TOWN OF BRISTOL, RHODE ISLAND

TECHNICAL REVIEW COMMITTEE

Technical Review Committee Agenda
Tuesday, December 03, 2024 at 11:00 AM
Community Development Office Conference Room, 235 High Street,
1st Floor, Bristol, RI 02809

Property located at **206 Bayview Avenue**. Assessor's Plat 47, Lot 3. Owners: Fair Wind Properties, LLC. Zoned: R-10.

©4 SITE - PROPOSED 1" = 30'-0"

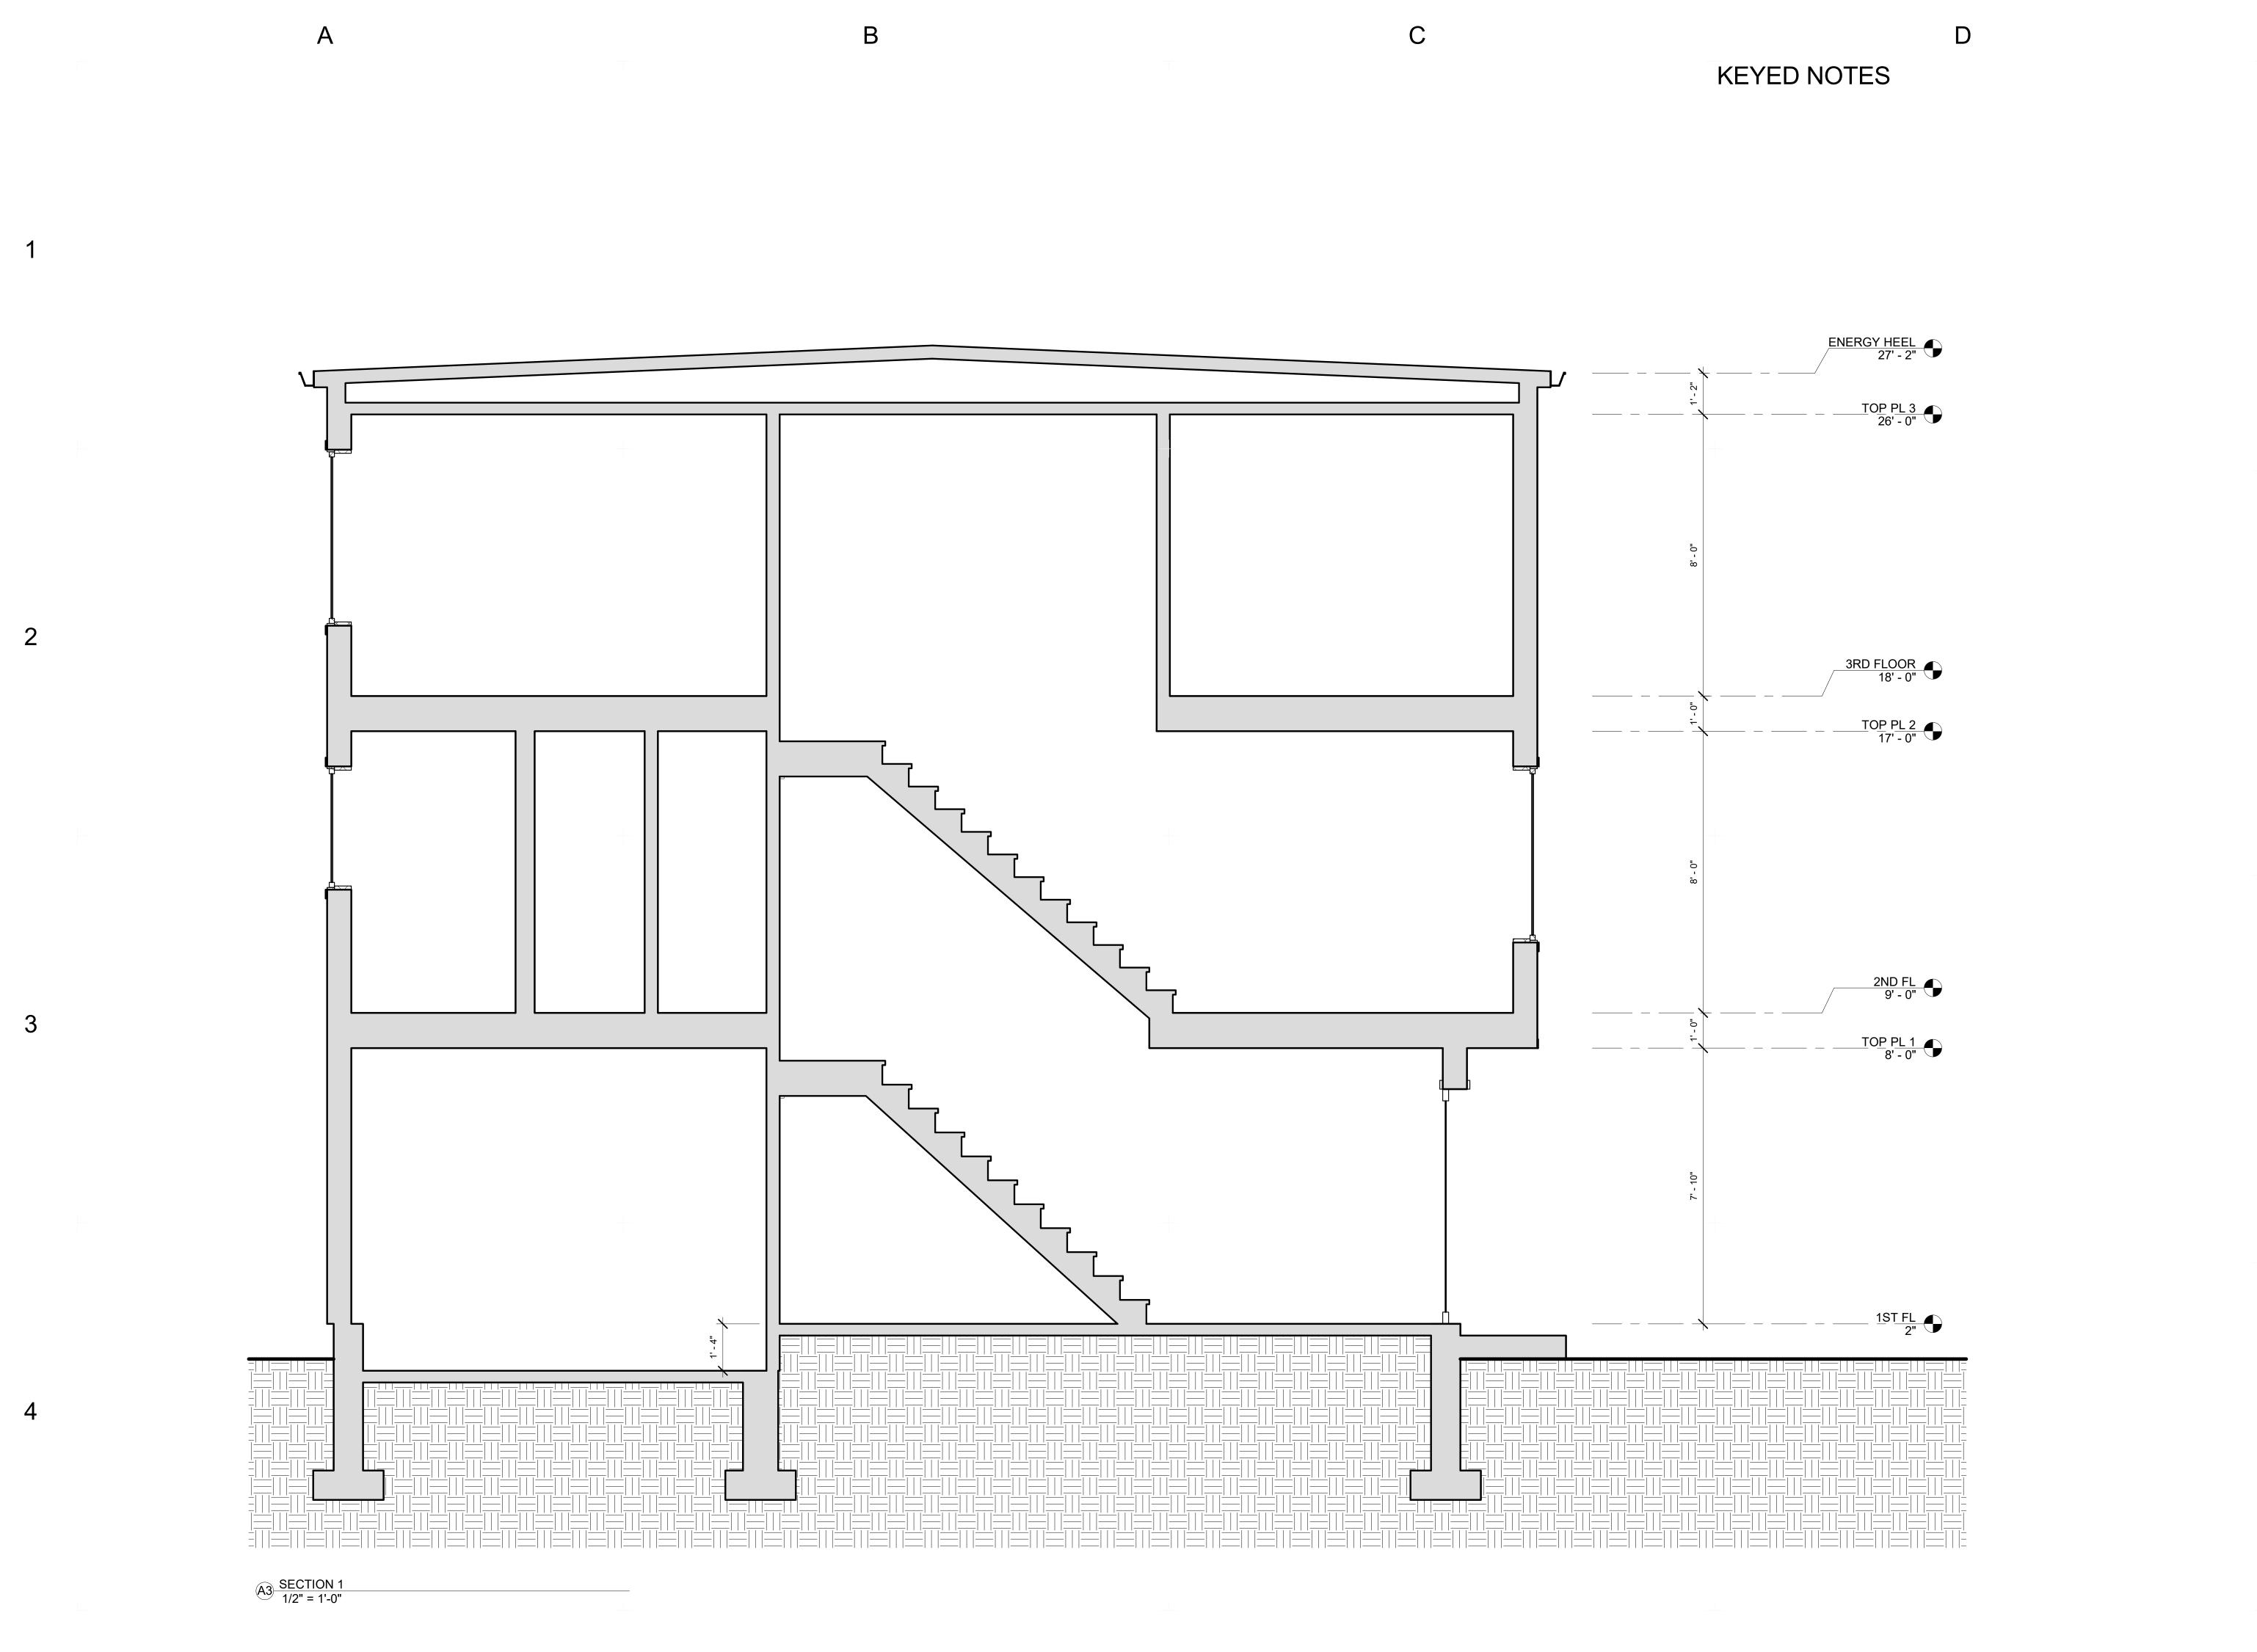
The applicant indicated there was room on the sight for plowing snow which would go to the south side were the drainage is. Ms. Williamson questioned the drainage location on the south side with all the drainage concentrated in one area rather than spread out along the development in several different areas. The concentrated location could cause impacts to the abutters.

Ms. Williamson also noted that there is only one play indicated being a 12x24 space, there is no buffer against the manufacturing and there is no land for any landscaping. The applicant noted that there was

The TRC discussed the density proposal and the concern about the overdevelopment of the site. The consensus was that the proposal was too dense and that two of the buildings (8 units) should be eliminated so that there are 12 new dwellings for a total of 15 units with the 3 existing. This is more in line with the density based on the inclusionary zoning requirements. With the reduced density, the total affordable housing units would be 4.

- 5 out of the 20 units will be affordable units. These units will be allocated in the new units proposed.
 - o 5 3 bedroom units
- Adding 3 new buildings instead of 5 and reducing the overall footprint of the units has led to reducing the overall building lot coverage from 23.1% to 16.2% (Reduction of 6.9%) the maximum building coverage for the zone is 25%.

- Reducing the overall building footprint of the entire project by 6,420sq ft. This
 amounts to eliminating approximately 2 full buildings of the original building
 footprint from the site plan (the town asked for 2 buildings to be removed)
- Going from 80 bedrooms total including the current 3 family to 58 bedrooms including the current 3 family (reduction of 22). Again this reduction in bedroom count is equivalent to eliminating the 2 buildings that was discussed at the last TRC meeting.
- We will also reduce the bathroom count by 9.
